RIVERPLACE PARCEL 3
DESIGN ADVICE REQUEST II PACKAGE

03.28.2016

DAR | FEBRUARY 18, 2016

ADDRESSING THE SUBSTATION: VISIBILITY & THE SOUTH FACADE

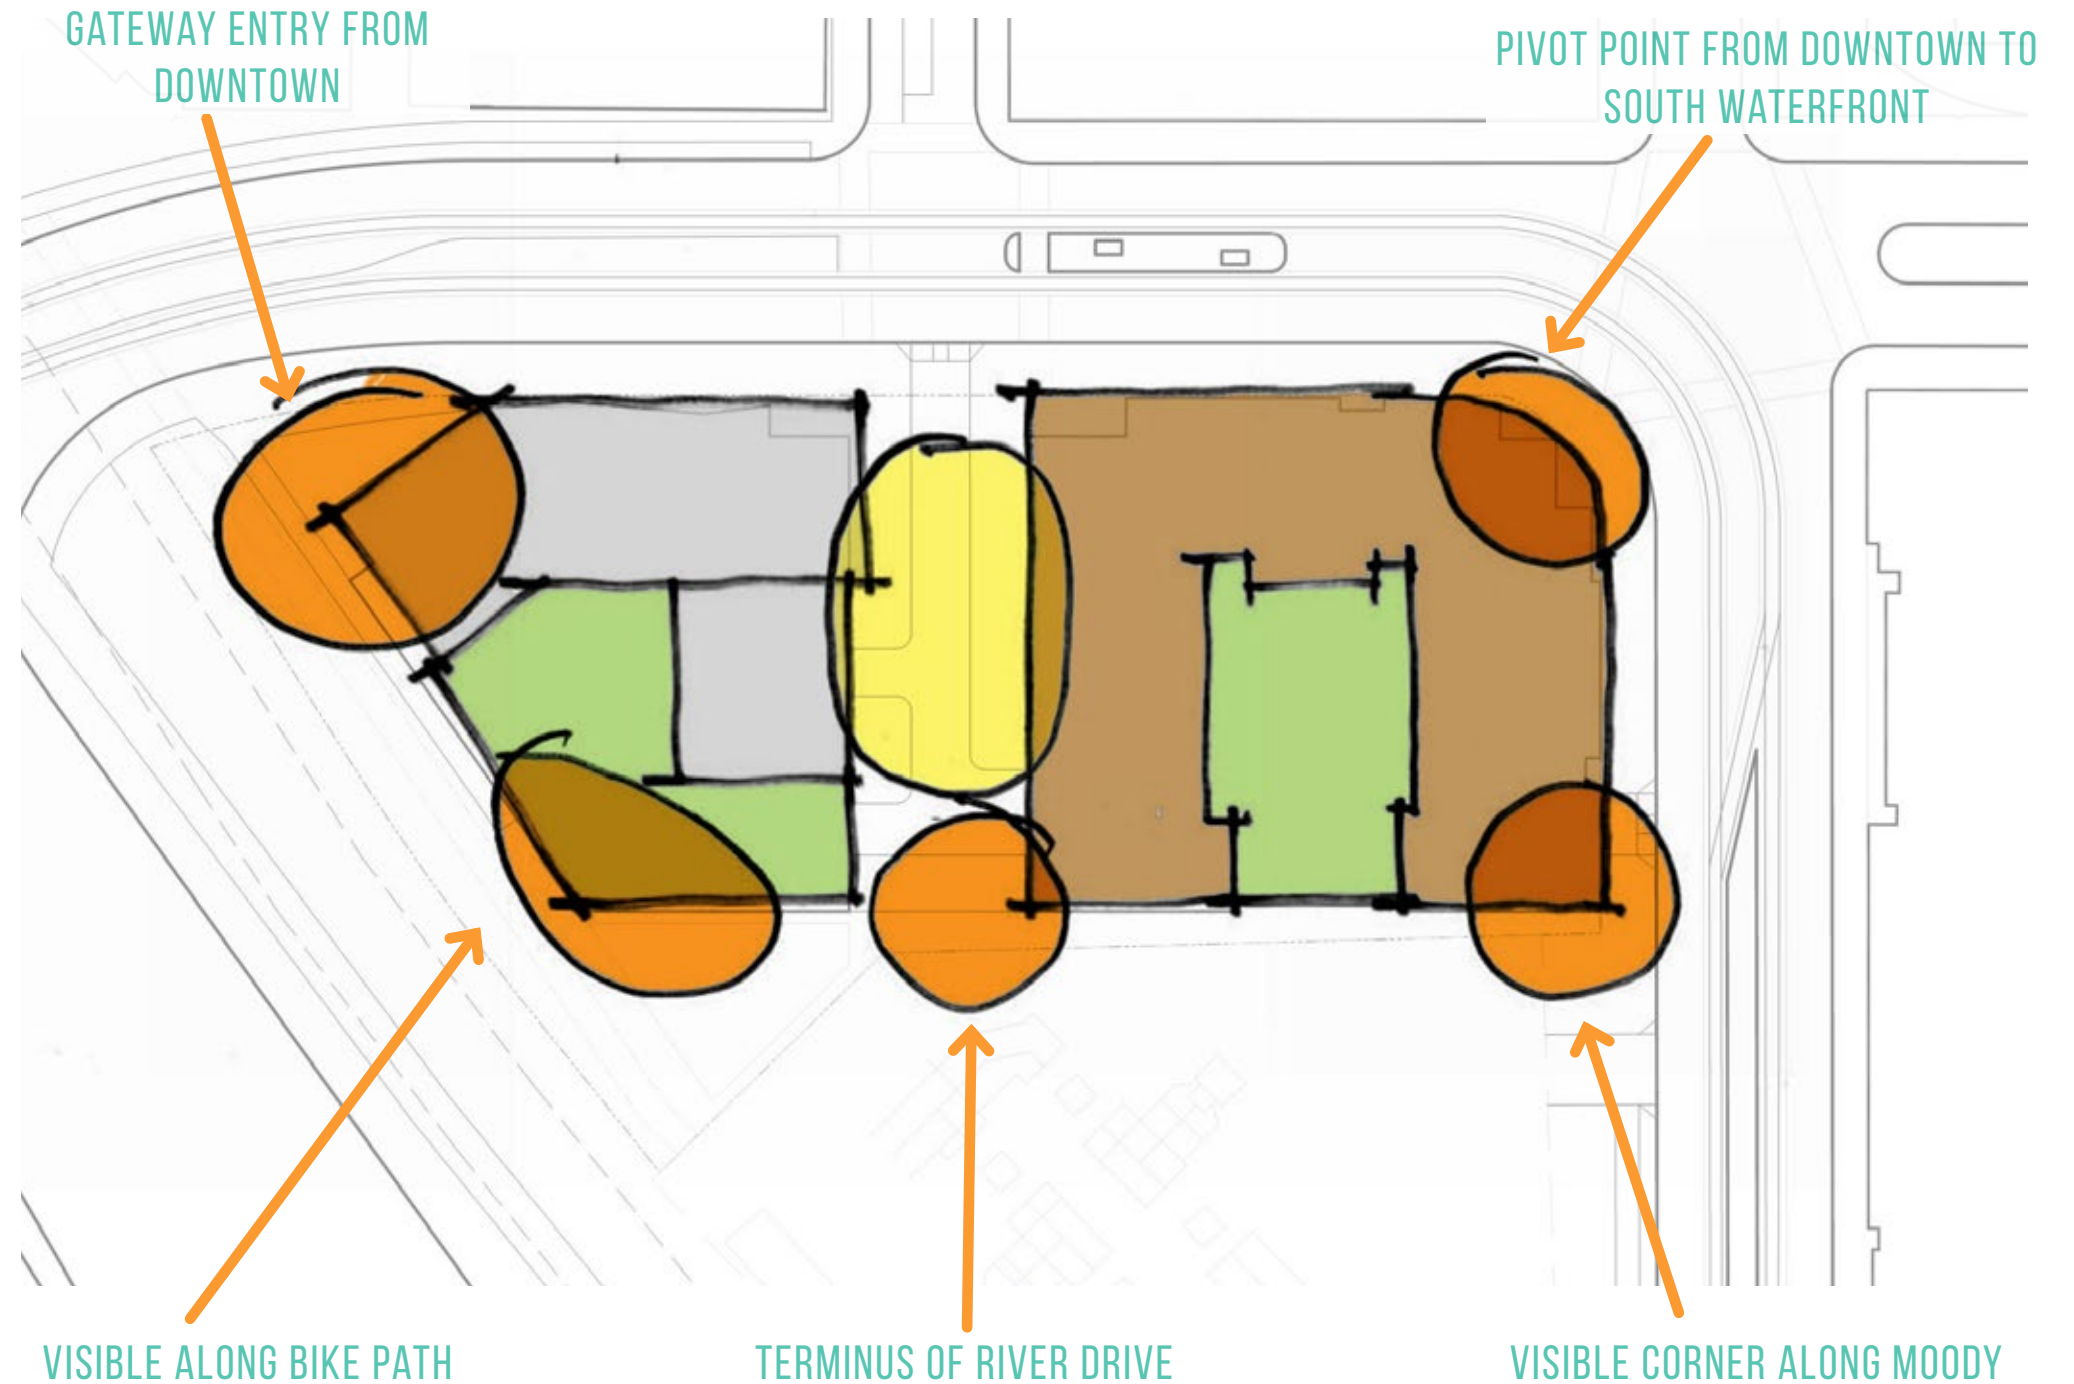
- Total gateway - serving as a gateway into downtown from the south.
- South side cannot be an afterthought.
- Opportunity for vertical green elements.
- Turning your back on the substation is not an appropriate solution "embrace the substation".
- Explore the potential to connect the southern termination of the private street with the bike path along the western edge of the site.

- View study to understand visibility from south and locate opportunities to create gateway.
- Develop trellis screen elements inspired by substation construction to connect buildings, create gateways.
- Connecting the bike path is a really intriguing possibility, there would need to be a bridge built to span the grade conditions, cross through light rail property as well as extensive coordination with trimet would be required. The funding available to this affordable project does not allow for connections.

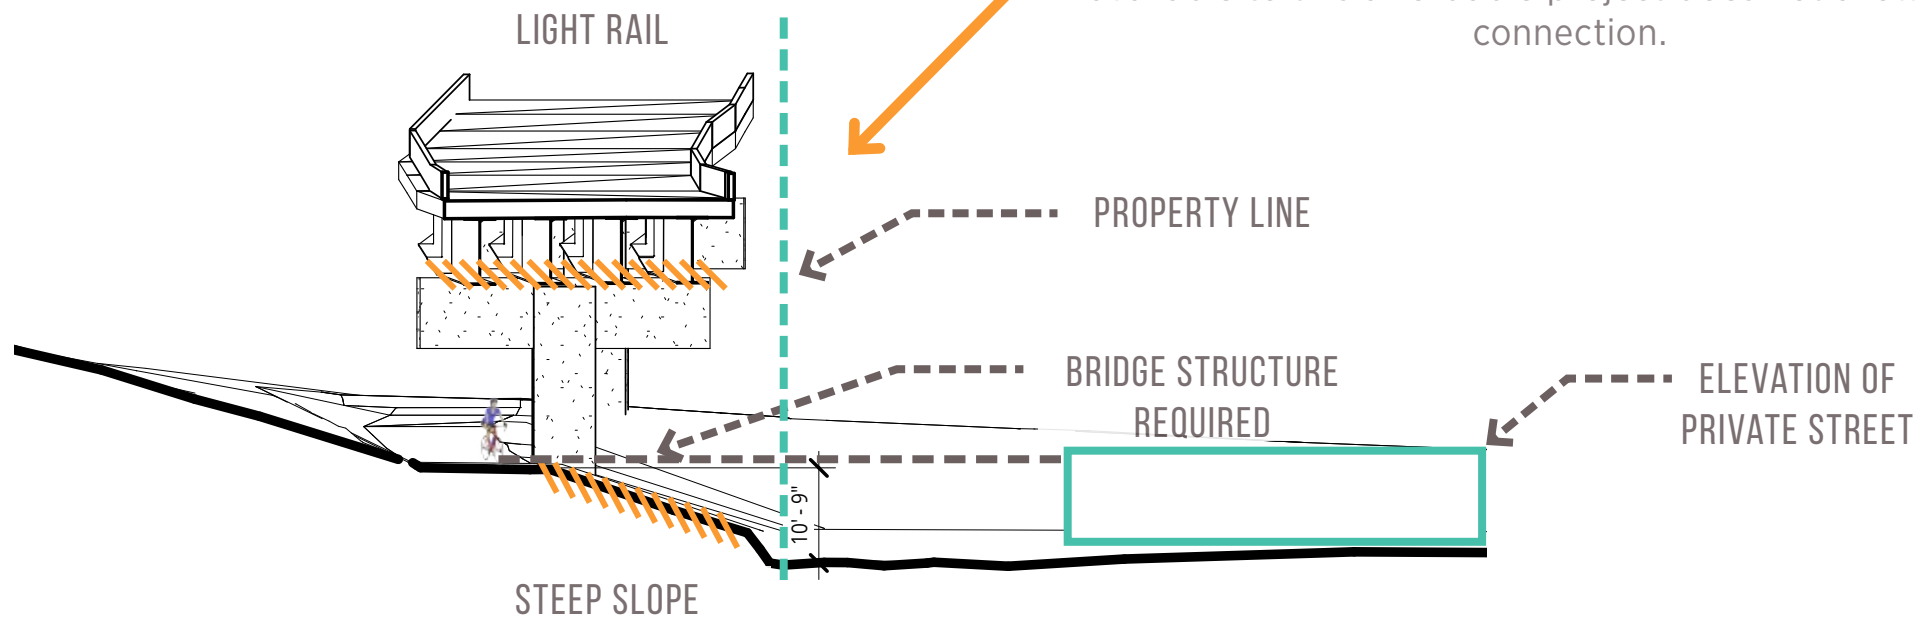
Potential location of bike connection suggested by commissioners, connecting the bike path is a really intriguing possibility, it would need to build a bridge to span the grade conditions, cross through light rail property. The funding available to this affordable project does not allow for this connection.

GREEN ELEMENTS

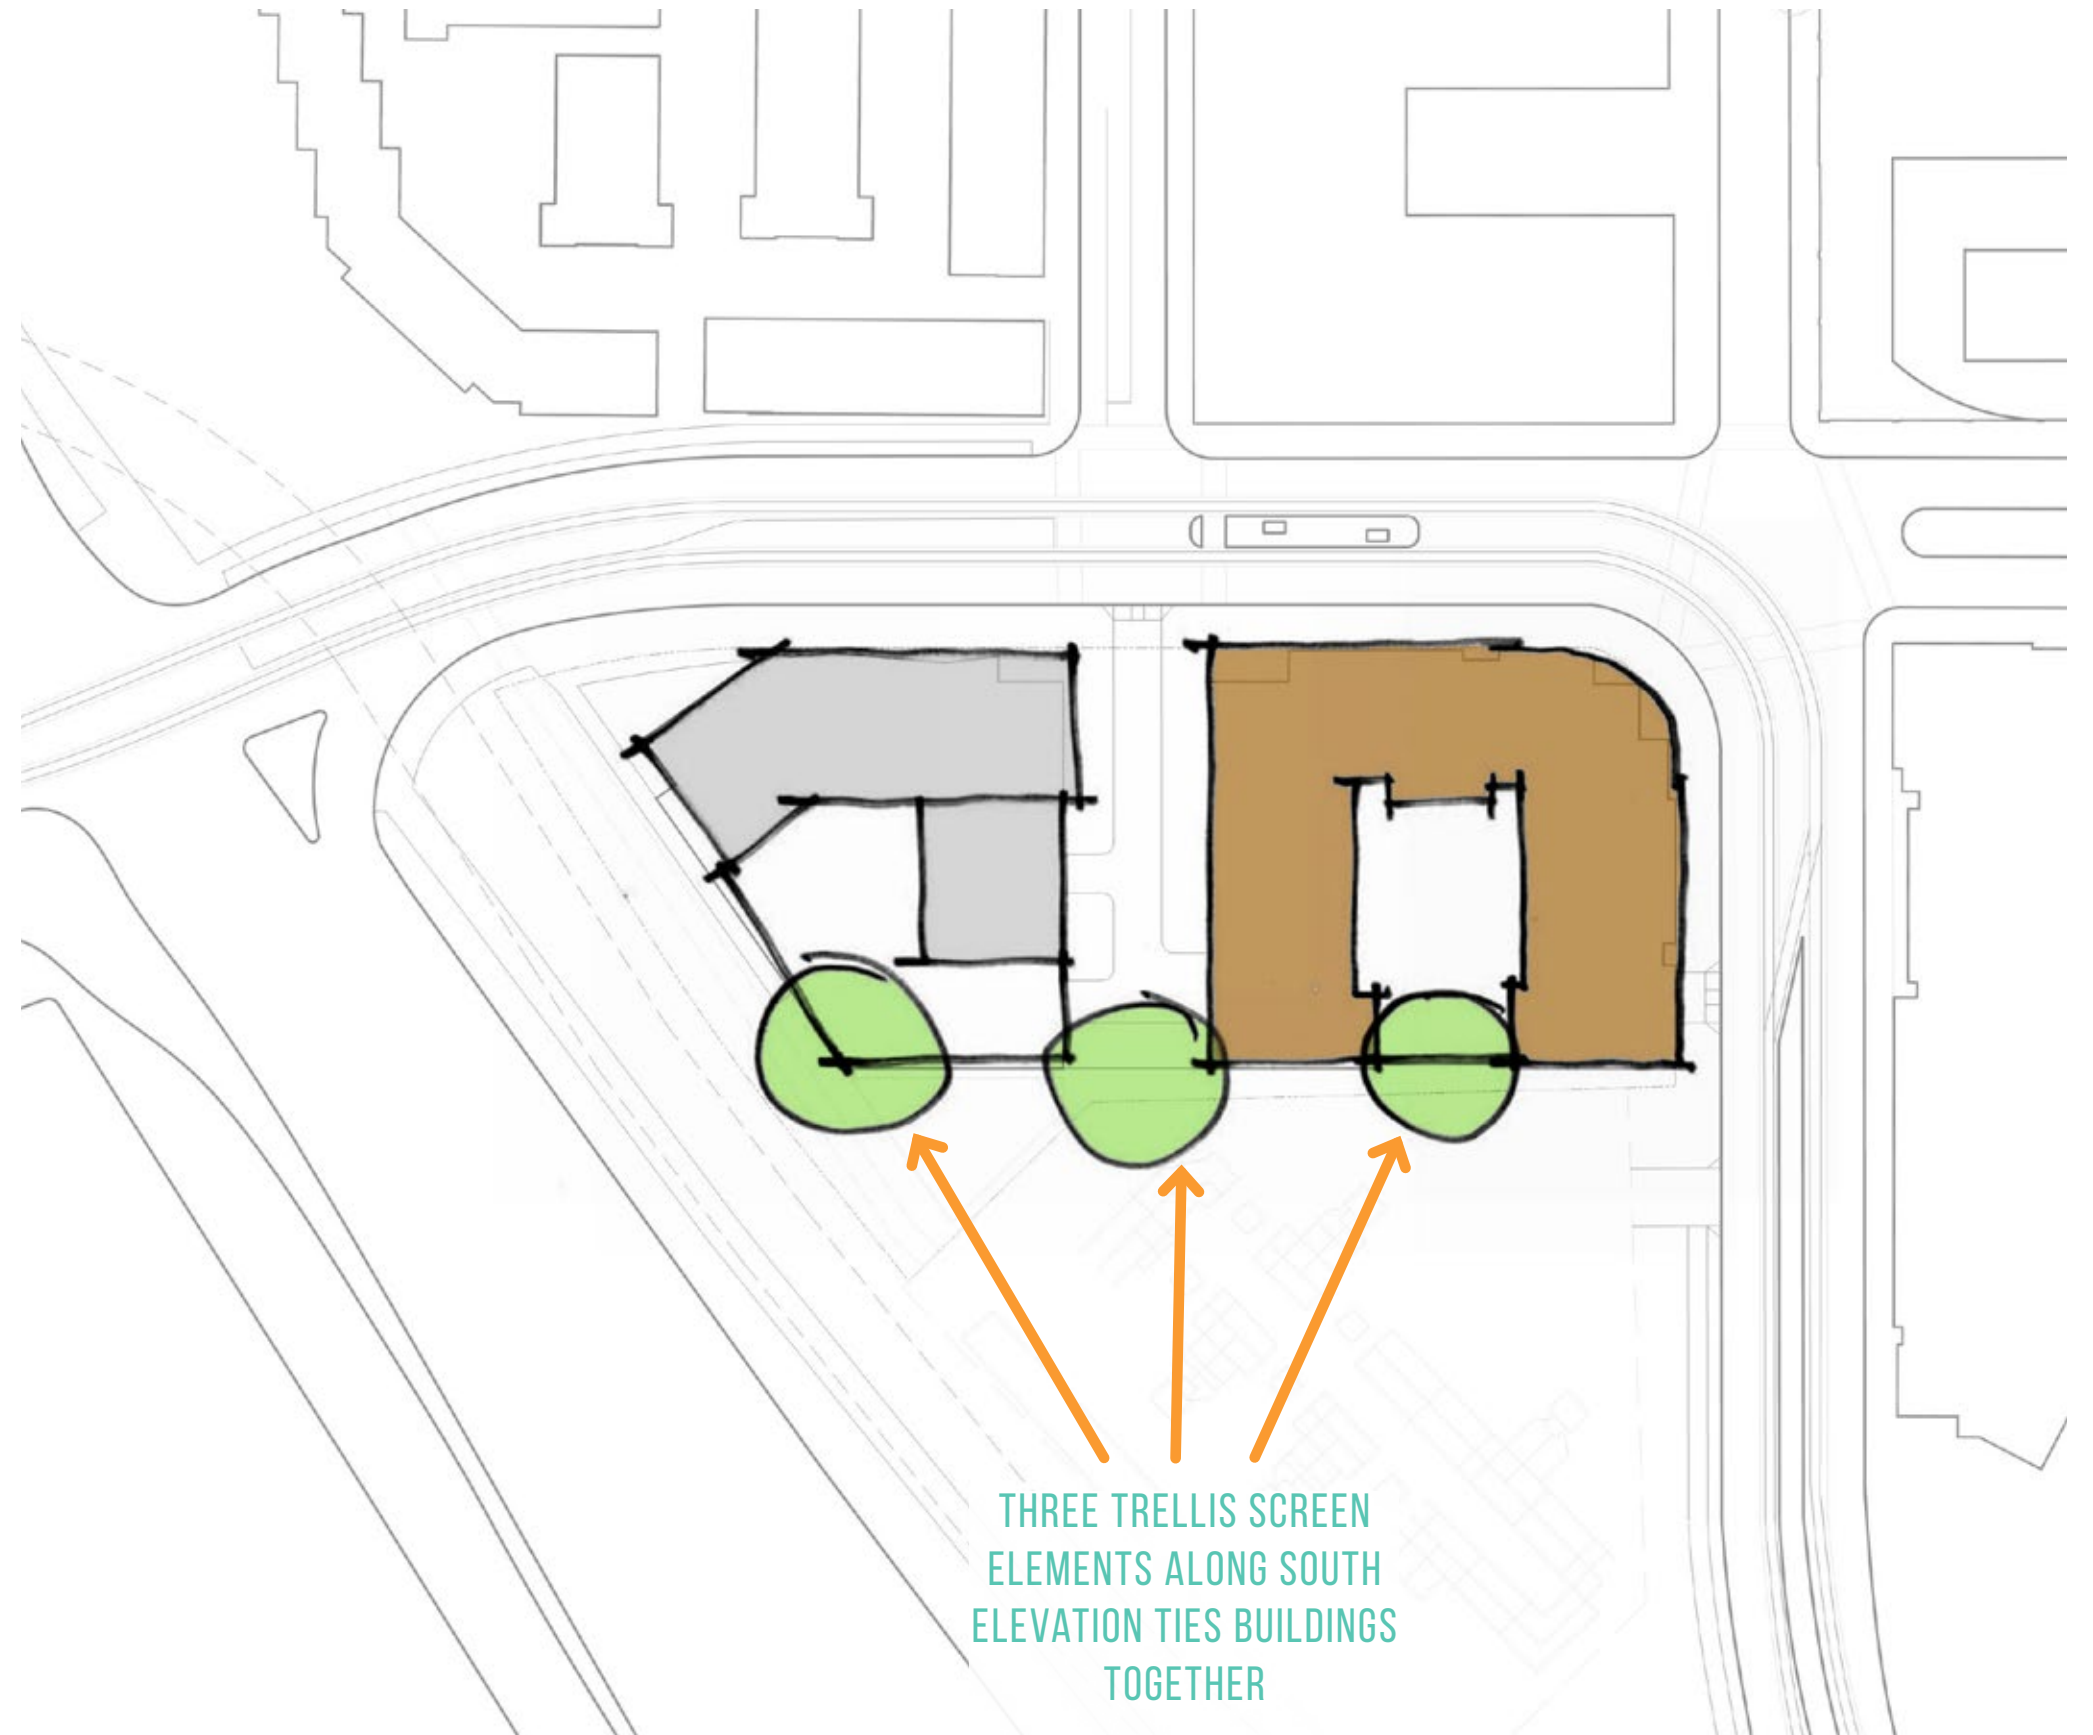
- Total gateway - serving as a gateway into downtown from the south.
- South side cannot be an afterthought.
- Opportunity for vertical green elements.
- Turning you back on the substation is not an appropriate solution "embrace the substation".

- Develop trellis screen elements inspired by substation construction to connect buildings, create gateways.

MASSING

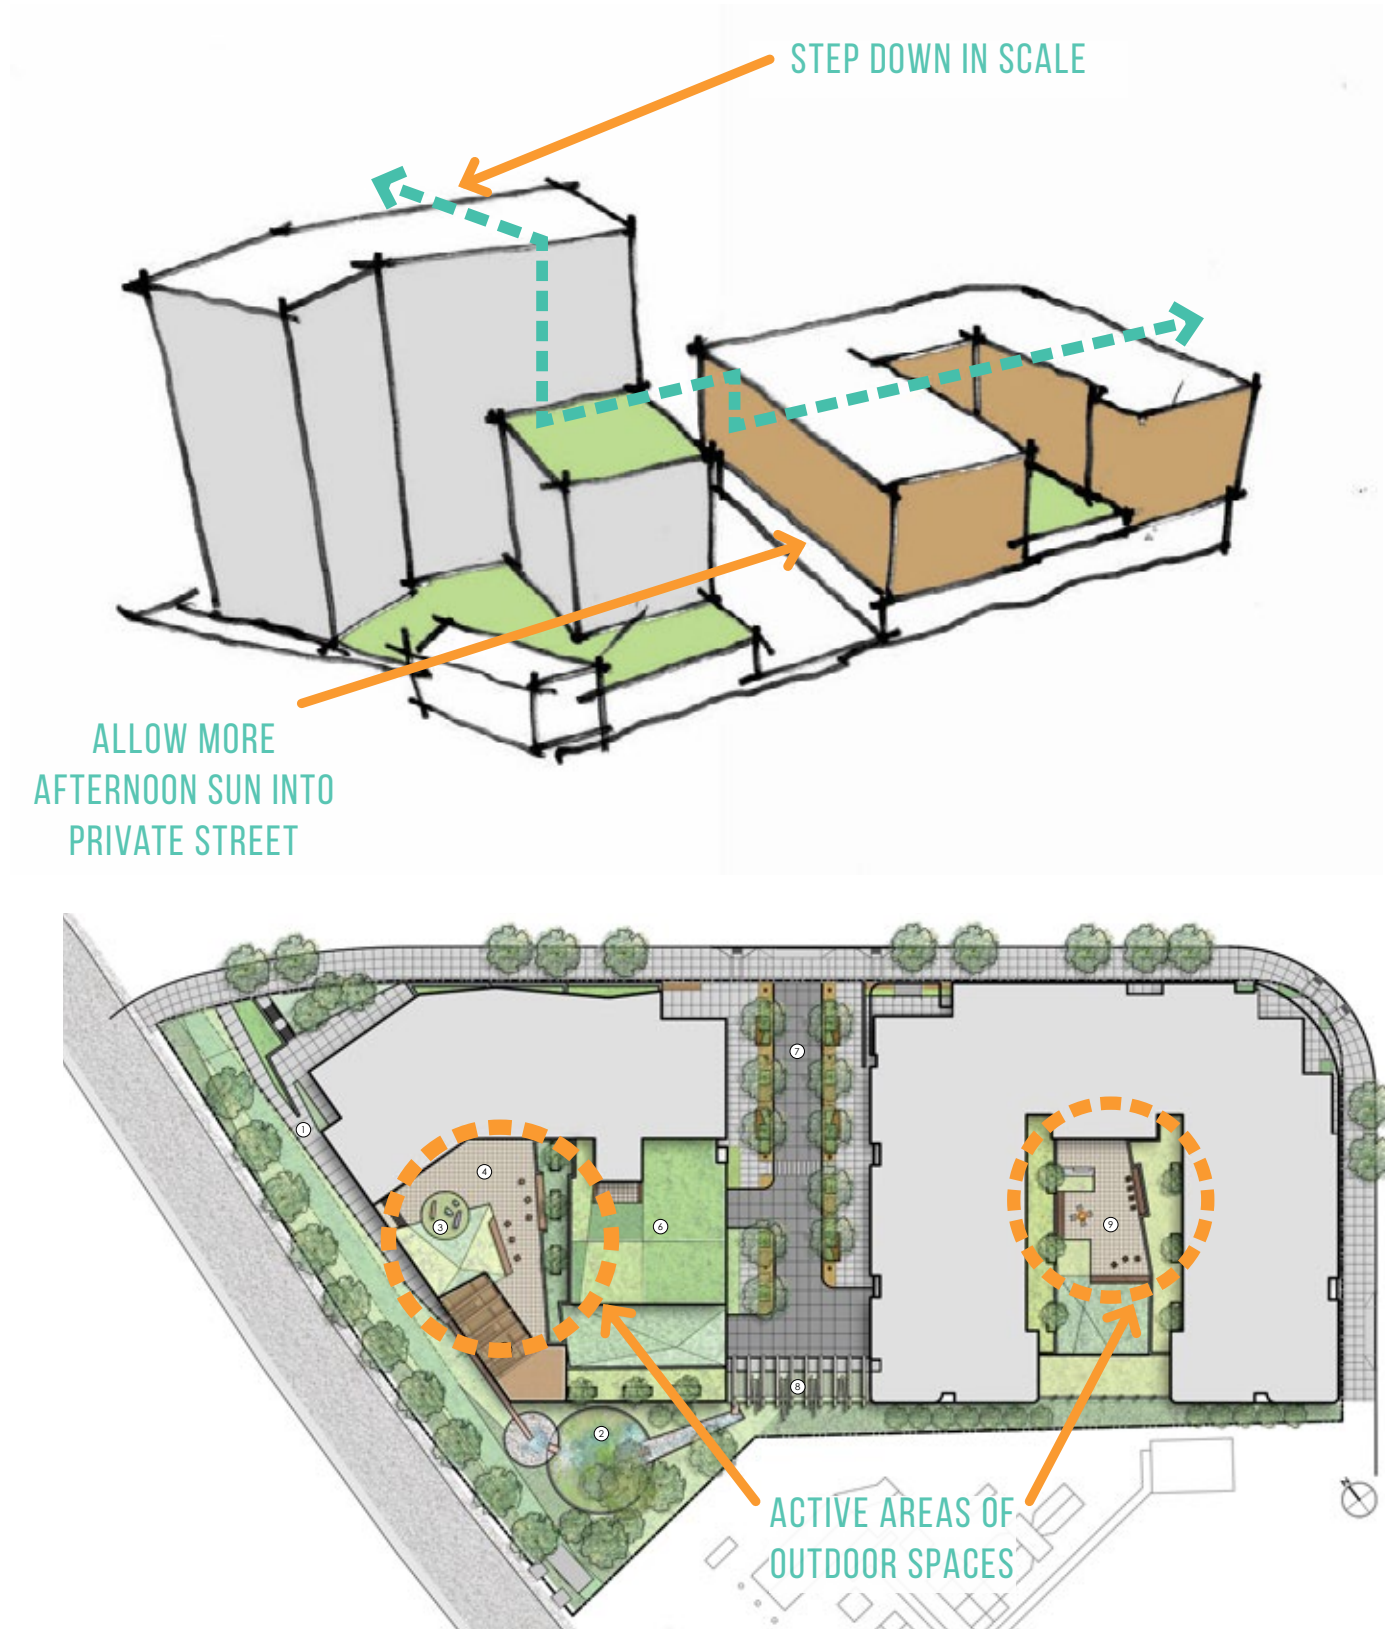
- What is the relationship between the two buildings?
- Are there shared elements that are going to tie the buildings together?
- East building is turning it's shoulder towards the private street.
- East wing of the West building feels tacked on.

- Like most of the Portland Central City we have divided the parcel into 200' blocks with a street separating them. The buildings are different in program, massing, architecture and the people they serve. This difference fits the scale of the context where one or multiple different buildings typically fill out a block, avoiding mega project scale.

- Landscape design, internal street and vertical trellis screens that address the substation to the south create a dialogue between the buildings and the context.

- Because the buildings are different, the longer wing of the East Building creates a more dynamic internal street.
- The active outdoor spaces on the podiums are pushed to the north creating separation from the substation additional outdoor space adjacent to the substation is not desirable.

- The East wing of the West Building is pulled back to allow more afternoon light into the internal street. It is taller than the East Building, stepping down in scale and addressing the internal street.
